RHODE ISLAND ATOMIC ENERGY COMMISSION
Rhode Island Nuclear Science Center
16 Reactor Road
Narragansett, RI 02882-1165

Docket 50-193

August 23, 2013

FIGURE 6.1 - ORGANIZATIONAL CHART

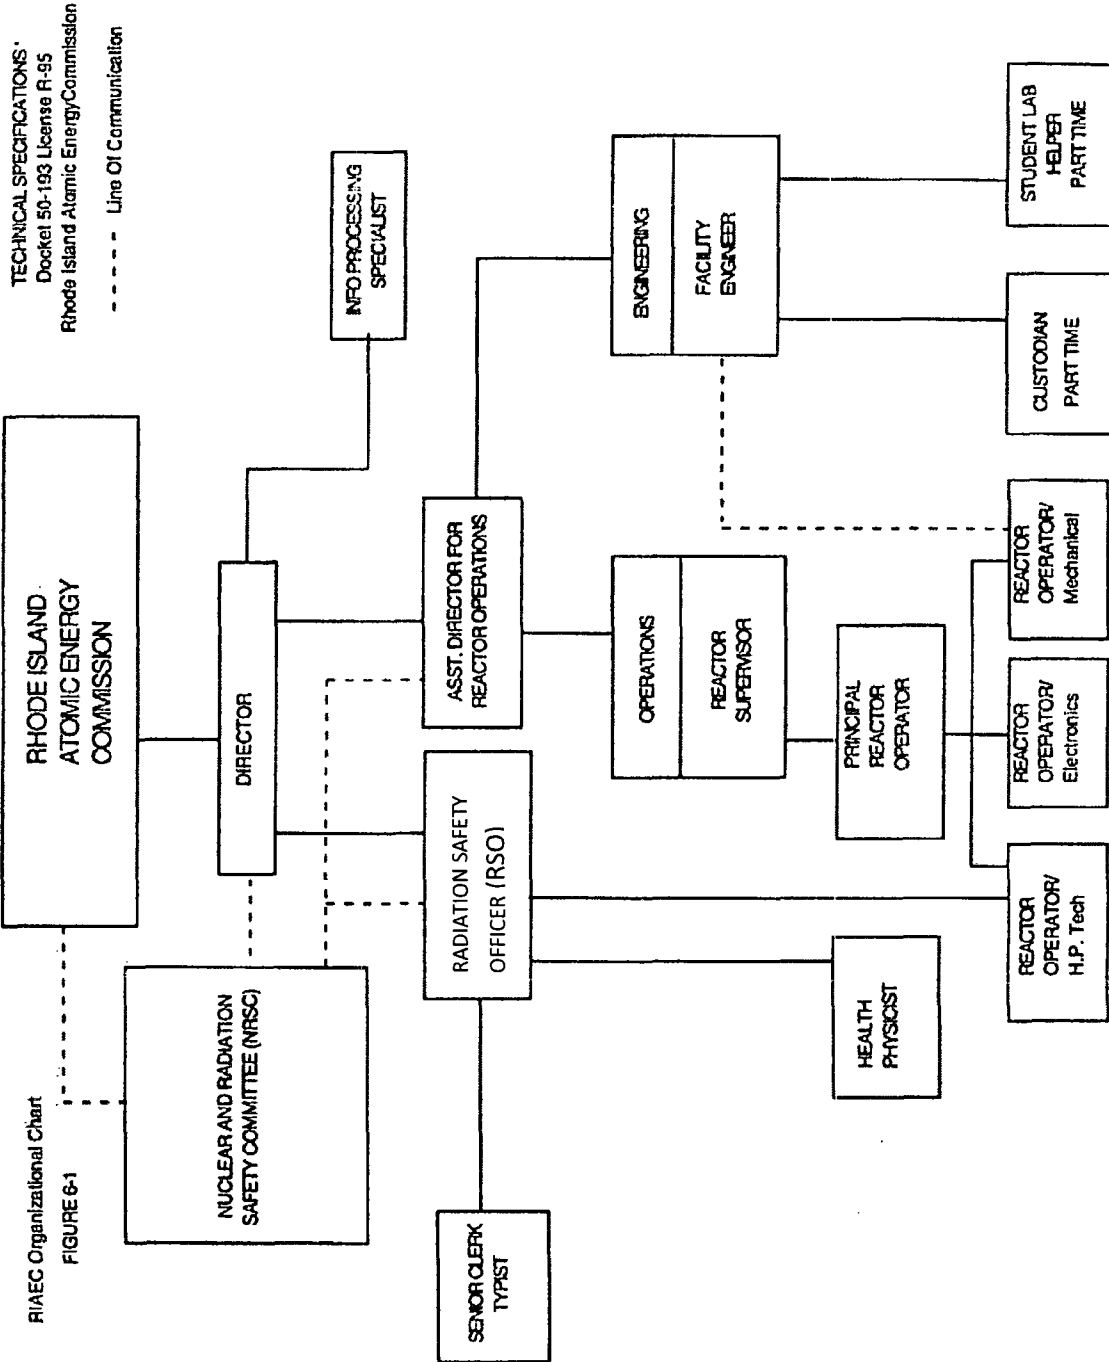
This will follow your question to me on our license amendment request for a change in title in our Organization Chart. I am attaching the actual chart revised to show the change in title of the ASST. DIRECTOR RAD & SAFETY (Radiation Safety Officer) to Radiation Safety Officer (RSO) per our discussion. Thank you for pointing out the multiple things that appeared in the recreated electronic version that had originally been sent. I trust this will make clear both the simplicity and intent of the change.
